Rezoning Transportation Analysis
Petition Number: Insert Zoning Petition #2021-270
General Location Identifier: 10502126, 10502127

Revision Log:

Date	Description
04-12-2022	First Review (AO)

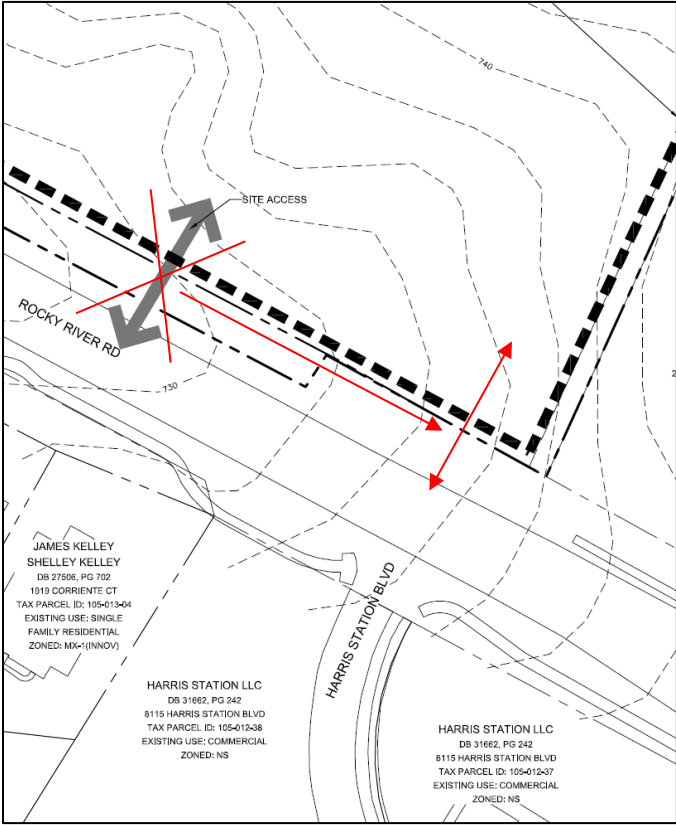
1. Curblin:

- a. **Rocky River Road:** Distance from centerline to back of curb: 19 feet

Label and dimension the curb and gutter from the centerline for each road on the site plan.

- 3. Revise site plan and conditional note(s) to commit to dedicate 35 feet right-of-way from the road centerline of Rocky River Road. The site plan shall label and dimension the right-of-way from the road centerline.

- 4. Revise site plan and conditional note(s) to commit to construct an 8-foot planting strip, and 6-foot sidewalk on proposed private street per Chapter 19 / Chapter 20 and commit to constructing bicycle facilities by locating the curb and gutter 19 feet from the center line of Rocky River Road and installing an 8-foot planting strip and 12-foot multi-use path along Rocky River Road to meet the City Charlotte BIKE Policy.

The site plan shall label and dimension both items from the back of curb and gutter.
